# Data Request Response #1

# Corby Battery Energy Storage System Project (24-OPT-05)

April 2025

This Data Request Response #1 to North Bay Interconnect, LLC and Corby Energy Storage, LLC's (Applicant)<sup>1</sup> Opt-in Application (Application) for the Corby Battery Energy Storage System Project (Project) (24-OPT-05), responds to comments that California Energy Commission (CEC) Staff have made as a result of their data adequacy review of the Application, as documented in their Determination of Incomplete Application and Request for Information letter dated December 9, 2024. The intention of this supplement is to provide all additional information necessary for Staff to find that the Application contains adequate data to begin an Opt-in Renewables site certification proceeding under California Code of Regulations, Title 20, Section 1877, and Public Resources Code, Section 25545, for the technical areas included in the submittal.

Figure 1 Burrowing Owl 2024-2025 Winter and 2025 Breeding Survey Results Corby BESS Project

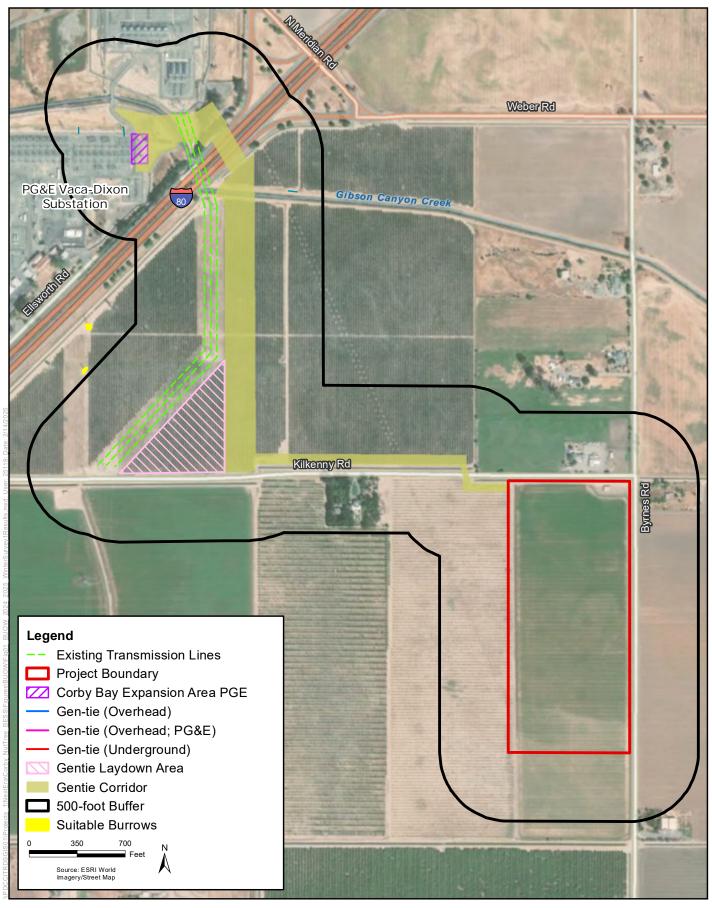
- b. Please provide a figure showing the location(s) where burrowing owls were observed in 2023 during the Swainson's hawk protocol surveys. In addition, please delineate the buffer surveyed on the figure and identify which parcels were inaccessible during the 2024 focused surveys.

No suitable or occupied burrows or burrow surrogates of sufficient size or burrowing owls were observed within the survey area (Figure 1 in Appendix A) during any of the non-breeding season surveys. Survey details for non-breeding season surveys are presented in Table 3.

No suitable or occupied burrows or burrow surrogates of sufficient size or burrowing owls were observed within the survey area (Figure 1 in Appendix A) during the 2025 breeding season survey. Survey details for the breeding season survey are presented in Table 4.

→I∠ ✓ICF Figure 1-1 Study Area USGS Map

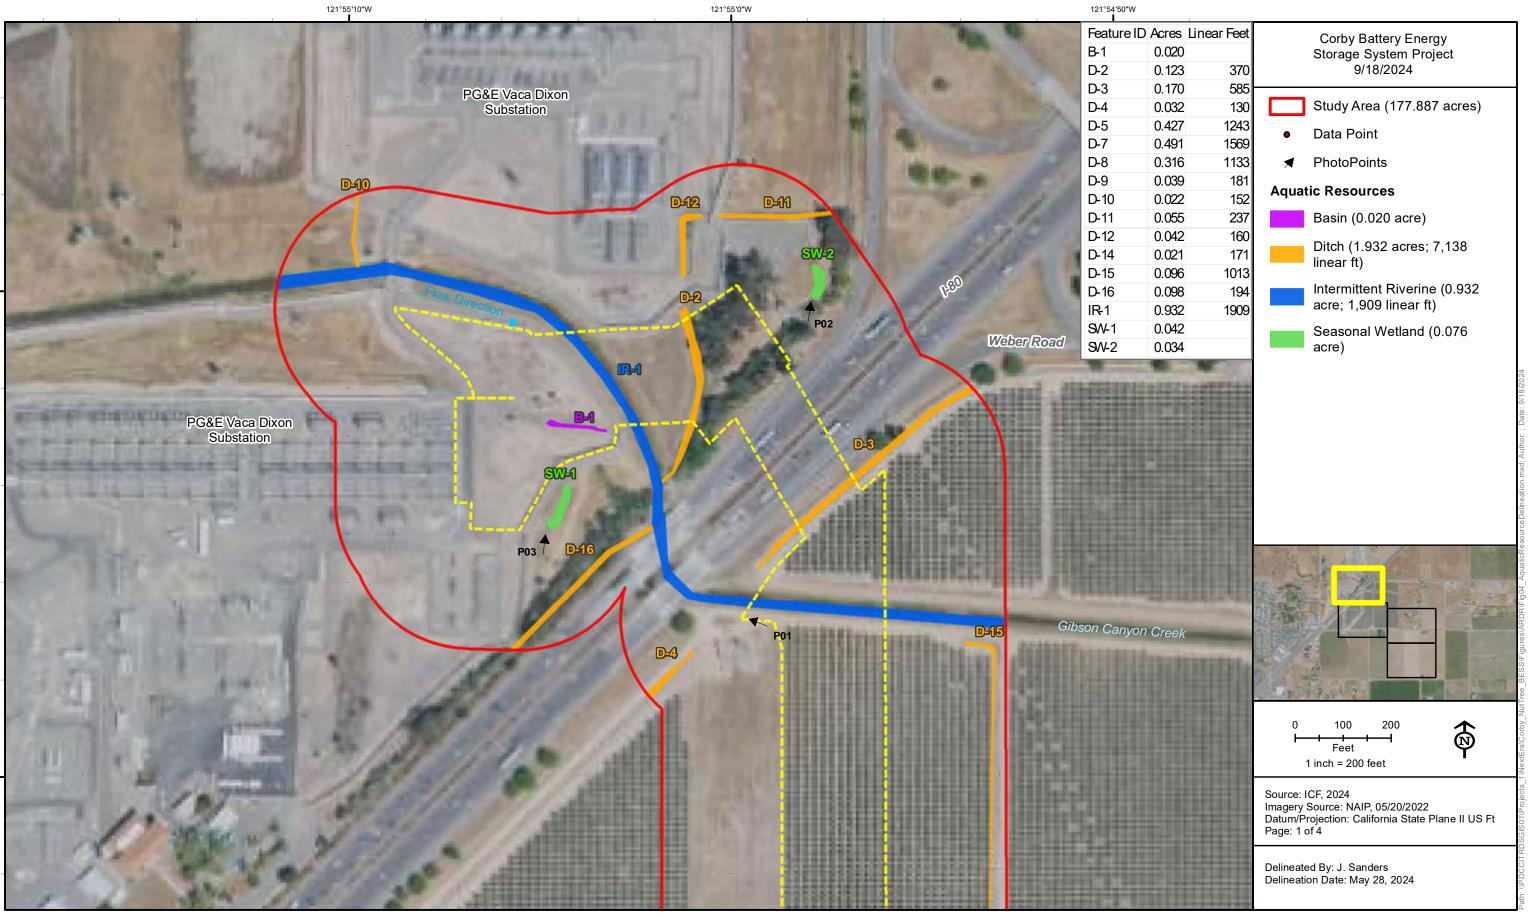
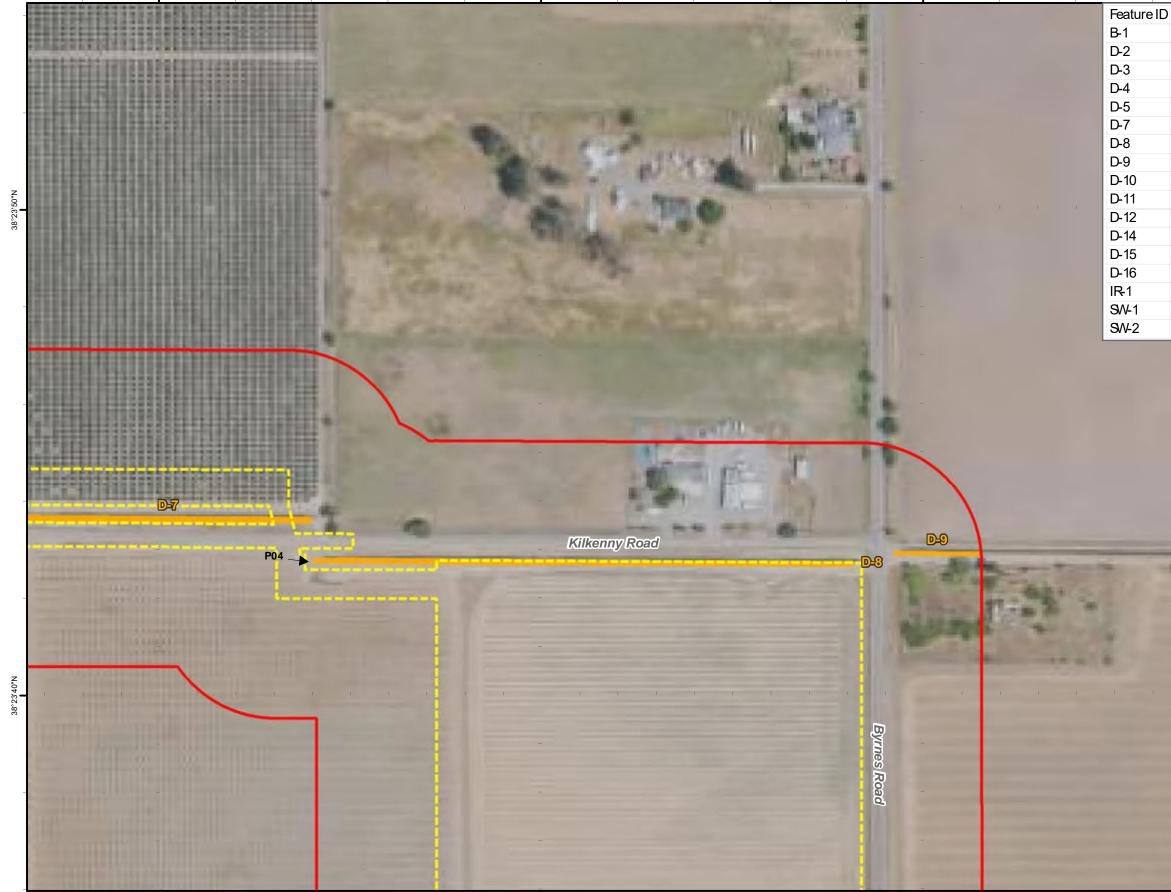
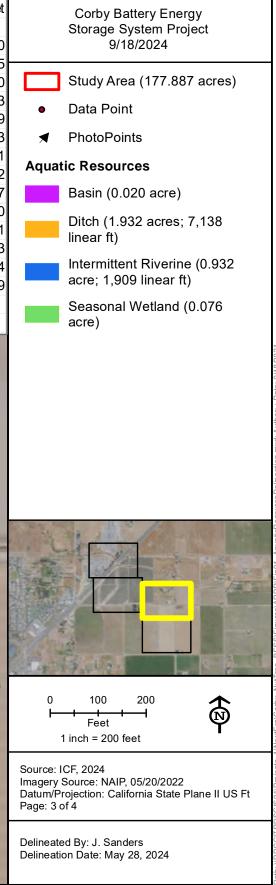
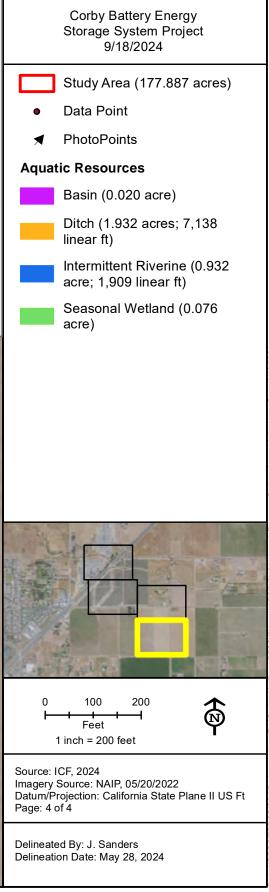
**DR BIO-2.** The Aquatic Resources Delineation Report, included as Appendix 4.4-D in Volume 2 App 4-4 of the opt-in application (TN 259894) describes the study area as encompassing approximately 175.053 acres; however, Figure 1-1 in Appendix 4.4-D and the Aquatic Resources Delineation Map, included as Appendix A of Appendix 4.4-D, both identify a study area of 286.636 acres. Please clarify the size of the study area (in acres) and provide updated figures and maps, as appropriate.

**Response**: The Aquatic Resources Delineation Report (ARDR) text and tables are correct. There was an error in Figure 1-1 and the Appendix A, Aquatic Resources Delineation Map. There are 13 mapped ditches with a total acreage of 1.932 acres in the study area.

A corrected Figure 1-1 and a corrected Aquatic Resources Delineation Map, Appendix A, are included as Appendix 3-D.
